Sigtronics Panel Mount Intercom Sidetone Modification

Intercom Models: **Sport 200** Circuit Board 1440 S/N 6202355 - to - 6202992
SPA-400* Circuit Board 1440 S/N 6053486 - to - 6069005
SPA-600* Circuit Board 1440 S/N 1101839 - to - 1102527
SDB-800 Circuit Board 1440 S/N 1151004 A & B - to - 1151485

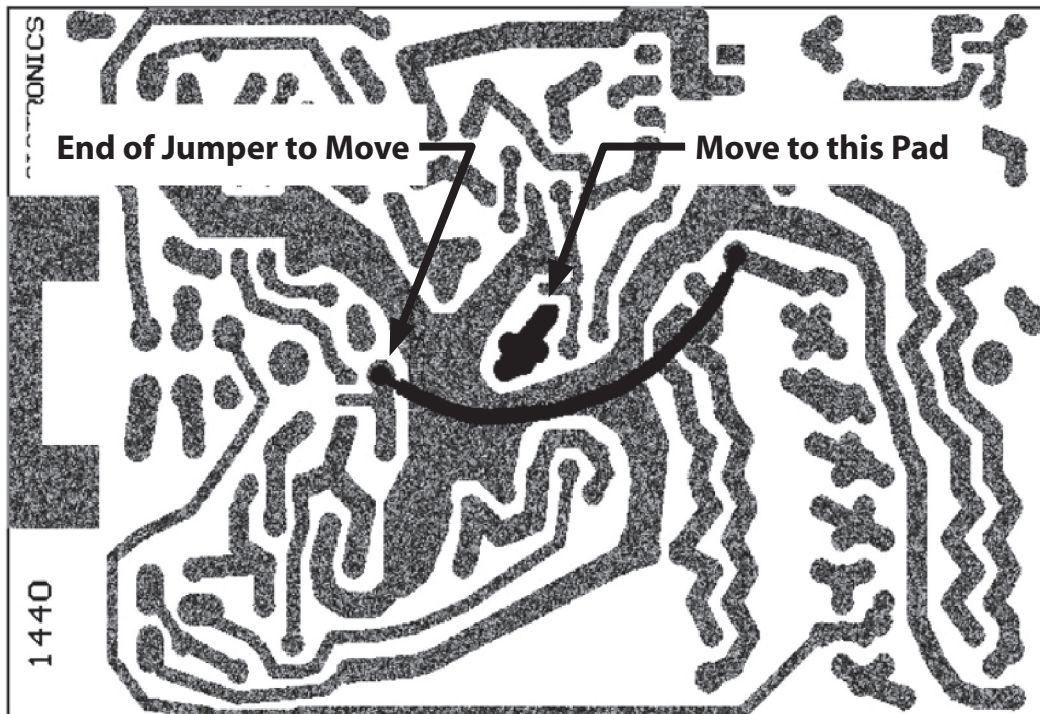
To complete the circuit board modification, remove the three screws securing the bottom cover to the case and carefully lift the cover from the case. Locate the jumper wire (usually brown in color) on the solder side of the circuit board. Note that the circuit board does not need to be removed from its case to complete the "side-tone" modification. Unsolder the wire from the solder trace at the end closest to the controls. Move the free end of the wire to the solder pad indicated in the attached drawing and solder the wire to the trace at the location specified.
